BALCH & COGLAS' PLAT OF CEDARGROVE*	
SCALE	1"=40'
DATE	June '58
DESIGN	JHR:RM:DP
DRAWN	DP
F.A.M.	
CHECKED	L.H.N.
FILE NO.	5809C-05
SHEET	3 OF 7

PLAN & PROFILE

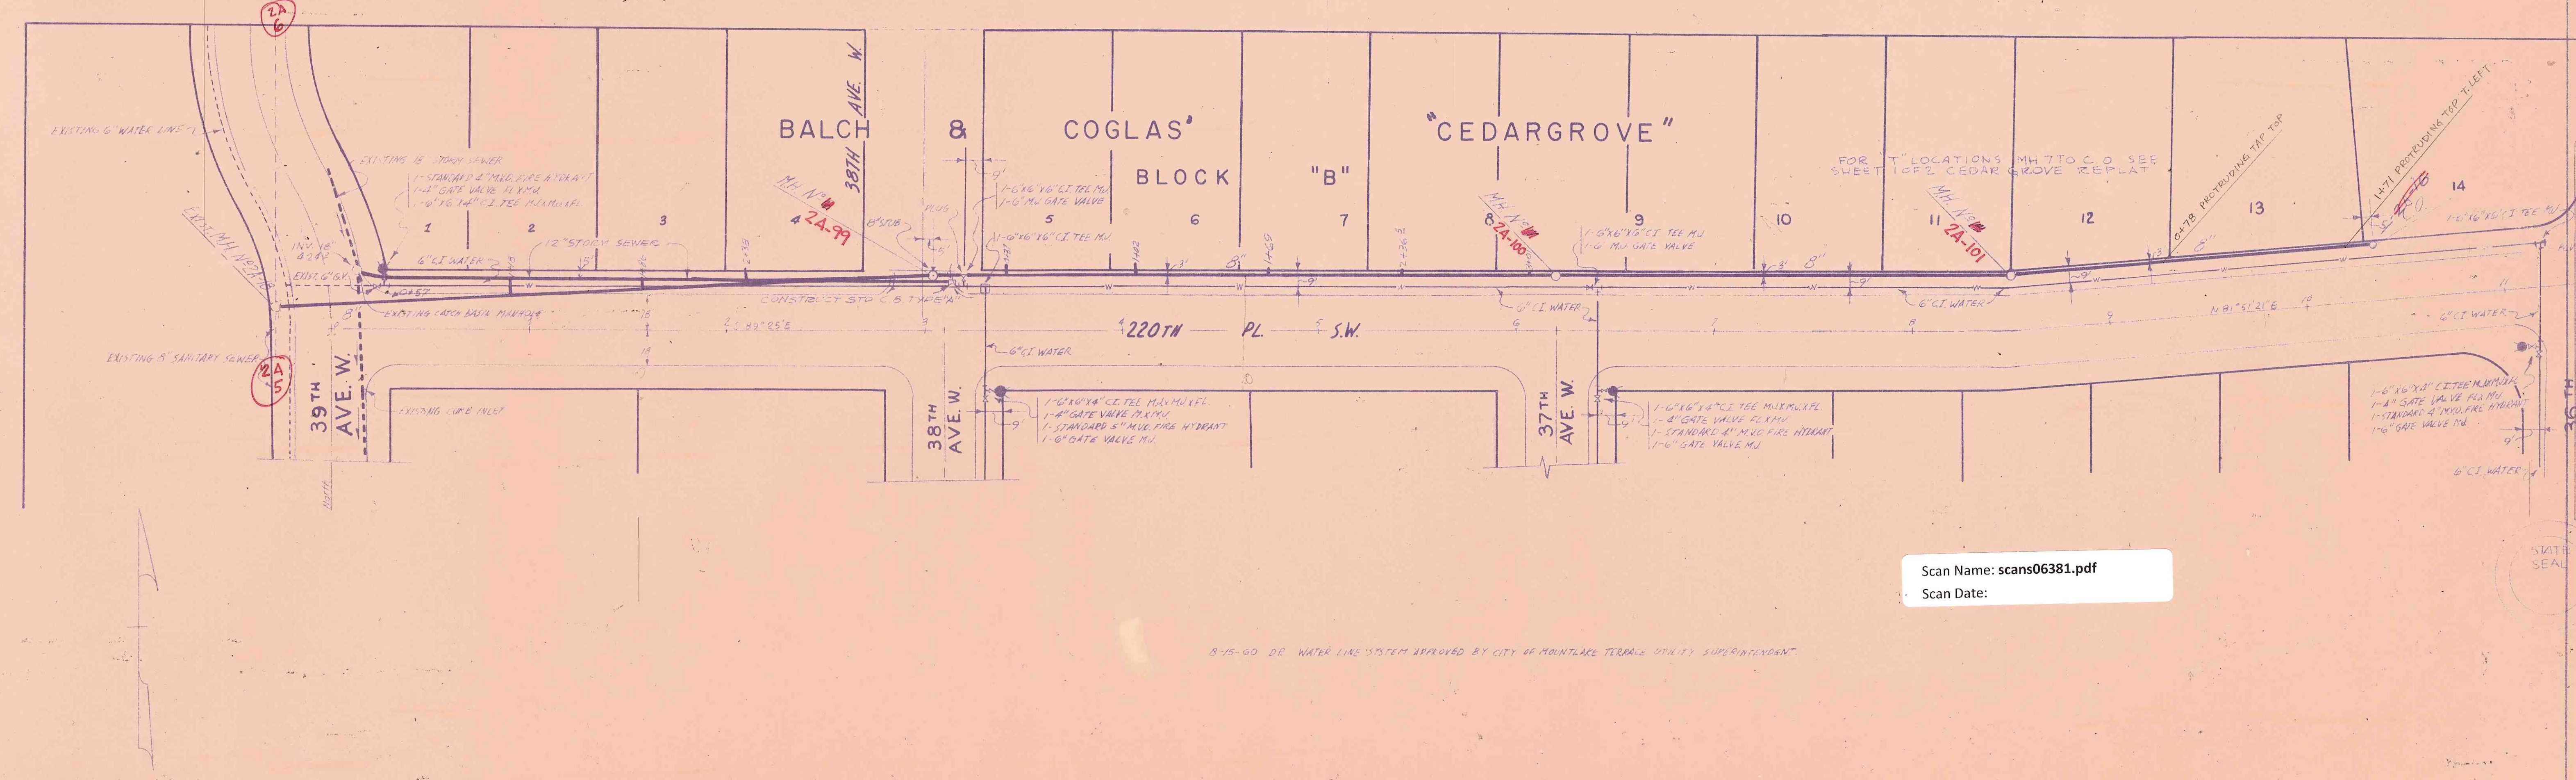
REVISIONS	
1. DE 1-20-80	REVIEWED PROFILE TO NEW SECTION.
2. DE 1-20-80	DESIGNED 12" DRAINAGE TIE-INS.
3. DE 1-20-80	CONVERTED WATER LINE TO 12" DRAINAGE.
4. DE 1-20-80	CHANGED THE MATERIALS.
5. DE 1-20-80	ADJUSTED SANITARY SEWER.
6. DE 1-20-80	CHANGED LOT BOUNDARY LINE TO FIT REPEAT.
7. DE 1-20-80	RELOCATED MANHOLE CHAIN ALONG THE SEWER LINE.
8. DE 1-20-80	CHANGED 24" DRAINAGE TIE-INS TO 12" DRAINAGE.
9. DE 1-20-80	ADDED 12" DRAINAGE TIE-INS TO 30' DRAINAGE.
10. DE 1-20-80	ADDED 12" DRAINAGE TIE-INS TO 30' DRAINAGE.
